PCN#20240806002.1
Qualification of RFAB using qualified Process Technology, Die Revision, Assembly site (MLA) & BOM option for select devices
Change Notification / Sample Request

PCN Number:	20240806002.1	PCN Date:	August 06, 2024
Title:	Qualification of RFAB using qualified Process Technology, Die Revision, Assembly site (MLA) & BOM option for select devices		
Customer Contact:	Change Management Team	Dept:	Quality Services
Proposed 1st Ship Date:	November 04, 2024	Sample requests accepted until:	September 05, 2024*

Sample product shipping label (not actual product label):

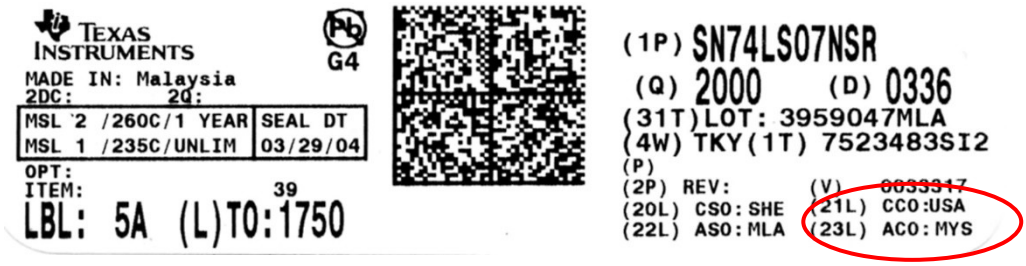
Changes to product identification resulting from this PCN:

Fab Site Information:

RFAB	**RFB**	**USA**	**Richardson**

Assembly Site	Assembly Site Origin (22L)	Assembly Country Code (23L)	Assembly City
TFME	NFM	CHN	Economic Development Zone
HFTF	HFT	CHN	Hefei
MLA	**MLA**	**MYS**	**Kuala Lumpur**
